Access Compliance Report

Public Rights-of-Way

(Curb Ramps)

Intersection ID: 21797	Main Street: GALLERIA_BV	Cross Street: MONROE_RD	Location: NE
ADA ID: 2D3B6913FF91	Ramp Type: Perp	Initial Pass/Fail: Fail	Overall Compliance: No
Codes/Mitigation Info/Possible Solution		Field Measurements/Component Compliance	
Severity Score: 18.75

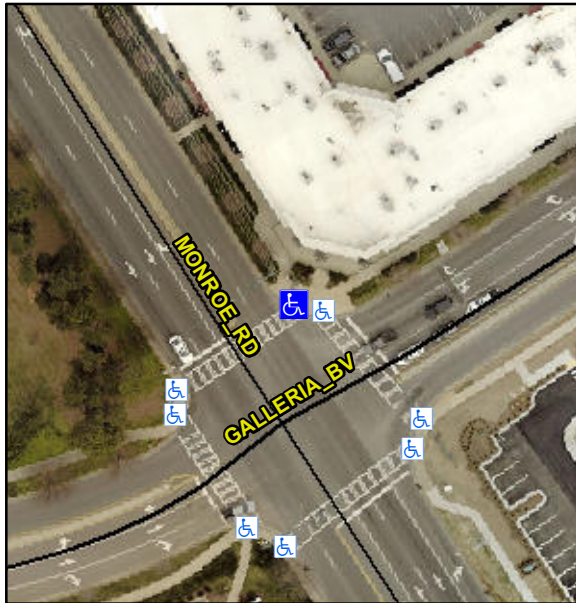
R304.5.1, R304.5.3

Compliance	Description	Data	Compliance	Description	Data
N/A	Ramp Length (in)	154.0	Yes	Ramp Slope (%)	5.6
No	Ramp Width (in)	35.0	No	Ramp XSlope (%)	3.5
N/A	Flare Type LT	N/A	N/A	Flare Type RT	N/A
N/A	Flare Slope LT (%)	N/A	N/A	Flare Slope RT (%)	N/A
N/A	Flare Traversable LT?	N/A	N/A	Flare Traversable RT?	N/A
N/A	Landing Length (in)	N/A	N/A	DWS Provided?	N/A
N/A	Landing Width (in)	N/A	N/A	DWS Contrast?	N/A
N/A	Landing Slope (%)	N/A	N/A	DWS Length (in)	N/A
N/A	Landing X Slope (%)	N/A	N/A	DWS Full Width?	N/A
N/A	Landing Curb? (Y/N)	N/A	N/A	DWS Offset (in)	N/A
N/A	Shared Landing?	N/A			
N/A	Gutter Ponding?	N/A	N/A	Gutter Slope (%)	N/A
N/A	Gutter Lip Ht (in)	N/A	N/A	Gutter X Slope (%)	N/A
N/A	Painted X Walk1?	Yes	N/A	Painted X Walk2?	N/A
	X Walk 1 Direction	To SW		X Walk 2 Direction	N/A
N/A	X Walk 1 Width (in)	96.0	N/A	X Walk 2 Width (in)	N/A
	X Walk 1 Slope (%)	2.6		X Walk 2 Slope (%)	N/A
	X Walk 1 X Slope (%)	1.0		X Walk 2 X Slope (%)	N/A

Remove & Replace Entire Ramp.
